Title: Advisory Committee on Reactor Safeguards
526th Meeting

Date: Thursday, October 6, 2005

UNITED STATES NUCLEAR REGULATORY COMMISSION'S
ADVISORY COMMITTEE ON REACTOR SAFEGUARDS

NEI 04-02 Figure 5-1 Revision 0

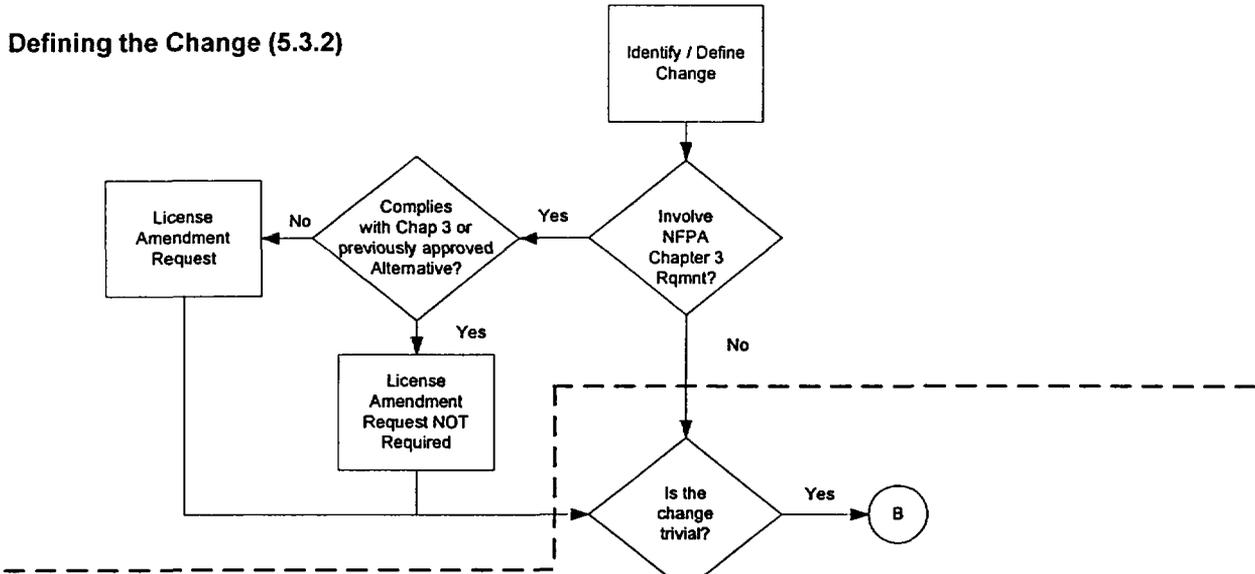
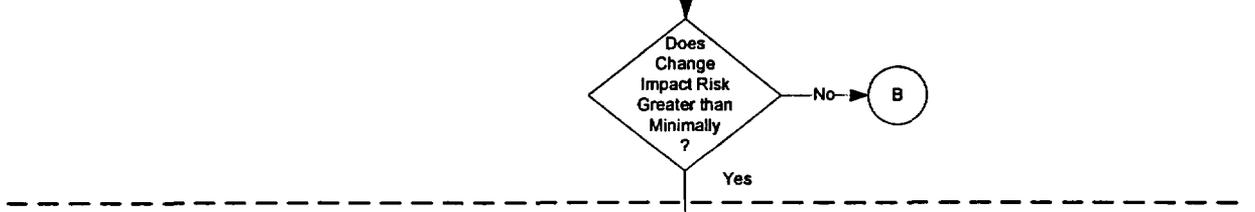
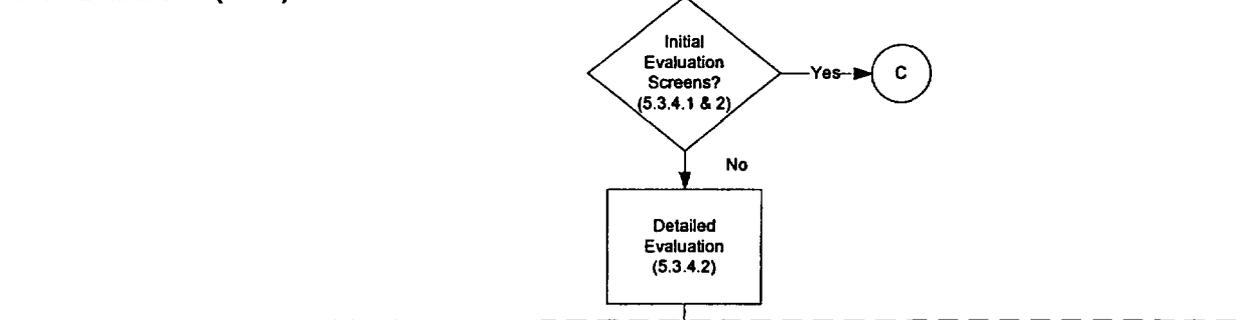
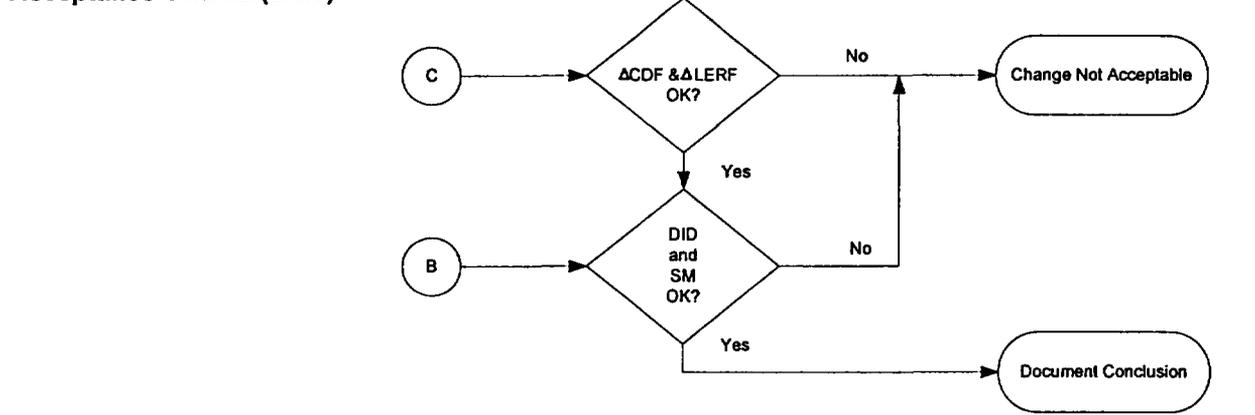
19 First specific comment was that the
20 initial fire modeling approach should not be used as
21 an alternative to estimates of changes in CDF and
22 LERF. The way we addressed this was to revise
23 Figure 5-1 in NEI 04-02 and --

9 MR. RANDLINSKI: Okay. The area of
10 concern is -- this is the plant change evaluation of
11 the process in schematic form. And this is from NEI
12 04-02. It's Figure 5-1. This was the previous
13 revision, Revision 0, which is covered up by that
14 five. The area of concern was this path here, which
15 is the approach -- the fire modeling approach to
16 evaluating a change, and it was shown as a parallel
17 path along -- in parallel with the risk assessment
18 path.

NEI 04-02 Figure 5-1 Revision 1

NEI 04-02 Figure 5-1 Revision 0

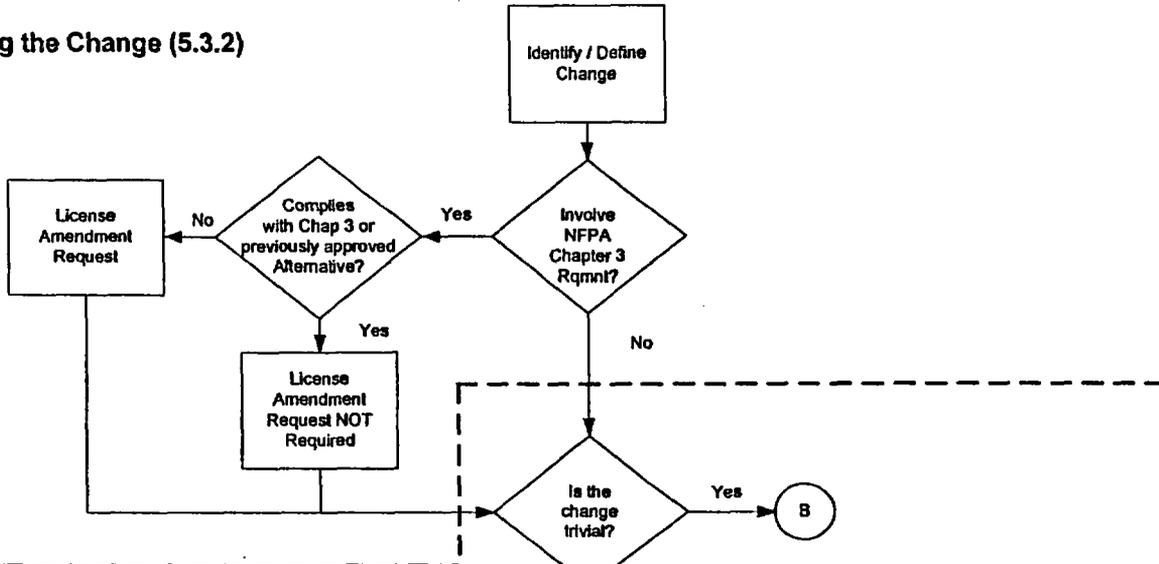
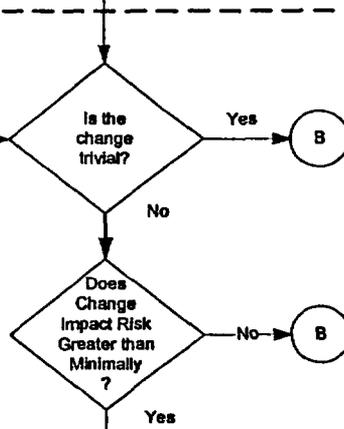
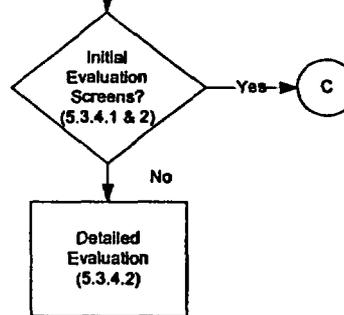
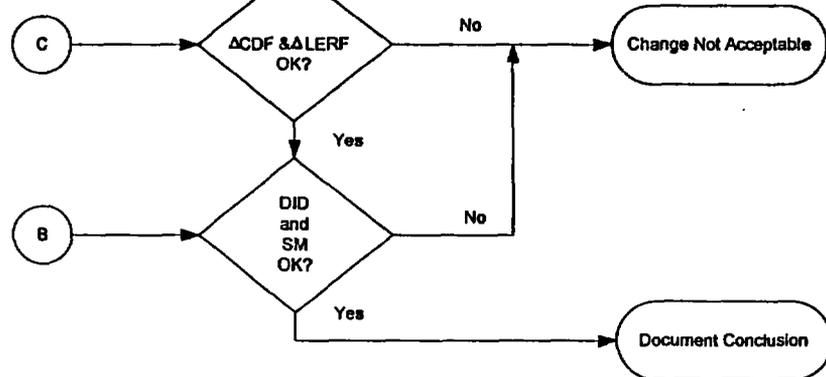
- ACRS Comment: The “initial fire modeling” approach should not be used as an alternative to estimates of changes in CDF and LERF.
- How addressed: NEI 04-02 has been revised to eliminate this approach (See revised Figure 5-1)

NEI 04-02 Figure 5-1 Revision 1

Mark I GE2 CRD Piping Layout

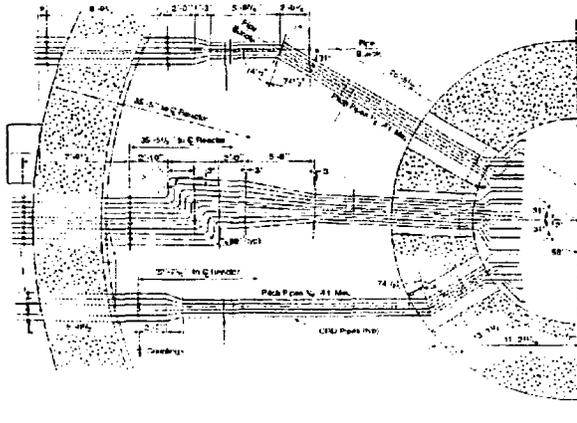
12 The differences are in the layout of the
13 CRD piping. The older plant Mark 1DII has three sets
14 of CRD bundles as shown on page 8 and they come out
15 from one side of the reactor. The other plants, next
16 page -- the other plants have four sets of bundles and
17 they come out diagonally off of it and in this picture
18 on the plant I've shown only two coming out, but they
19 are symmetric, two bundles one the other side.

7 MR. SHEIKH: So we looked at the different
8 containments. The first one was a GE2 containment,
9 Mark I which is the oldest plant and looking at the
10 layout of these plants, because the CRD piping is
11 located on one side, the RHR piping was not --
12 couldn't impact the CRD bundles. The RCS piping could
13 impact the CRD bundles and this is shown -- I don't
14 have it, but it's in the assessment, but if you go
15 back to page 8, it's the pipe sits in between the two
16 top bundles. The picture is there in the assessment
17 --

4 VICE CHAIRMAN SHACK: When I looked at
5 that, I was trying to figure out why I didn't end up
6 with that final reflected shape. There's a sort of a
7 white cross up there at the top. That's not a stop of
8 any sort. This thing is just straightened out so the
9 jet force is not bending, the moments are balanced and
10 that's the equilibrium configuration of the pipe.

FIGURE 2.20. Impacted 3" SCH 160 Pipe

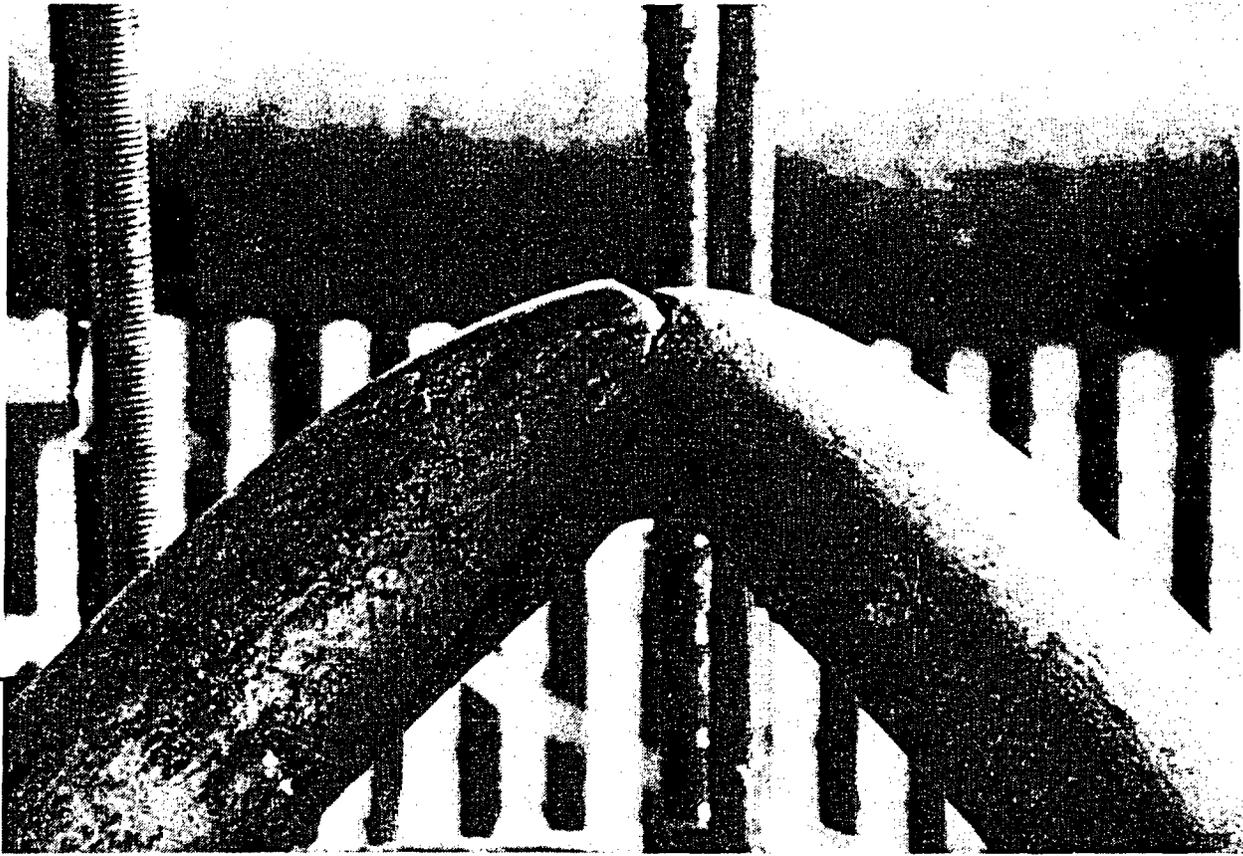
6 The idea is to show it as it bends, you
7 can still see that there's no complete blockage there
8 and this is also documented in the famous work done at
9 one of the national labs and passed on pictures which
10 shows that they did some actual test on pipe to pipe
11 impact. And they all show that the pipes never crimp
12 completely blocked.

13 VICE CHAIRMAN SHACK: But then my question
14 there was, okay, you demonstrated that for 3-inch pipe
15 and you recorded the result for a 4-inch pipe, but
16 isn't it easier to crimp a 1-inch pipe?
